By email: francesca.rowson@kpmg.ie
Date: 28th March, 2023
Our Ref: CORA-2127-LO-02-A
Planning Ref: SD22A/0342
Re: **Development at Tay Lane, Rathcoole**

In relation to the proposed age-friendly residential development proposed for lands located to the east of Tay Lane, Newcastle Road, Rathcoole, Dublin 24 for Riverside Projects Limited, we have reviewed the request for clarification of additional information, dated 25th January, 2023, received from South Dublin County Council (Decision Order Number: 0091) and would like to make the following comments in relation to the engineering items raised. These are addressed individually below:

SITE: TAY LANE, RATHCOOLE 91.2m3	JN230138 DRAWING NO.	1 PAGE NO.	15/02/23 DATE.	
TITLE: PLAN	NTS SCALE	LP DRAWN.	LP CHECKED.

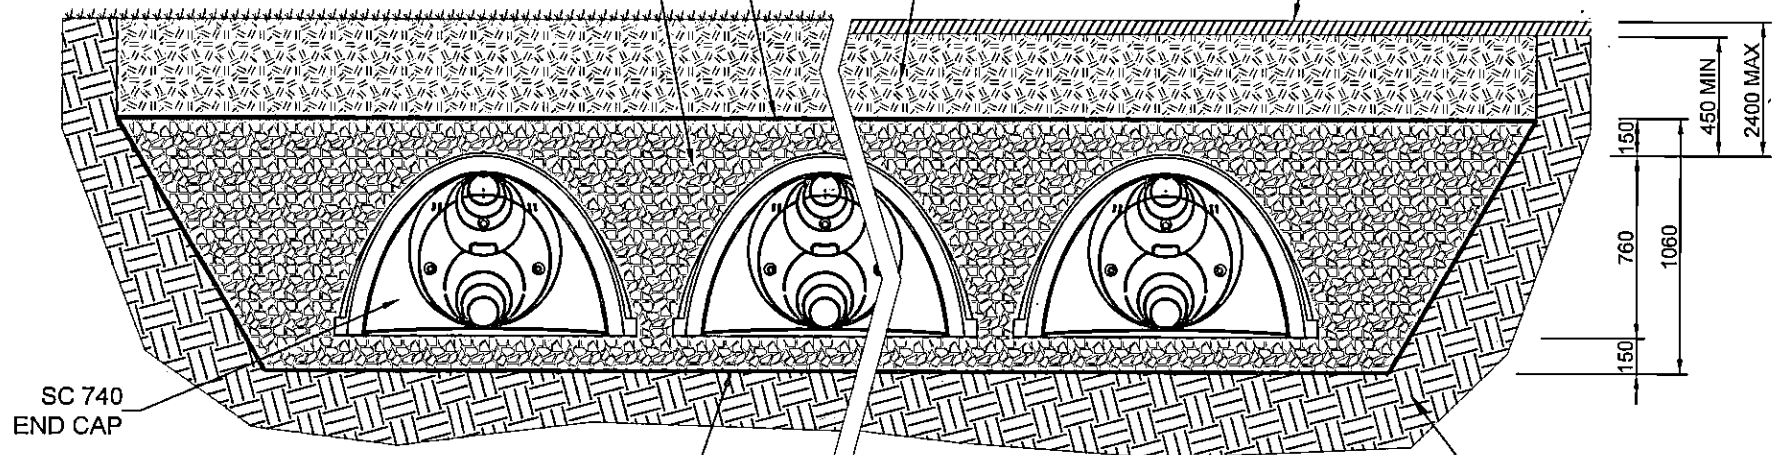
- D. Submit a drawings showing all SuDS systems in plan and cross sectional view. Show the treatment train and conveyance of surface water above ground over the site. Show the capacity in m³ of proposed SuDS systems.

As part of the discussions with Mr. Harkin, the Aquacell units proposed have been omitted in favour of a Stormtech system. A detailed design has been provided by Resolute Group which details the configuration of the soakaway which will provide the required volume. Calculations demonstrate that an overall volume of 82.8m³ of storage volume is required. The proposed Stormtech system provides an overall storage volume of 91.2m³. Calculations justifying the soakaway size along with the details of the Stormtech system proposed are appended to this letter.
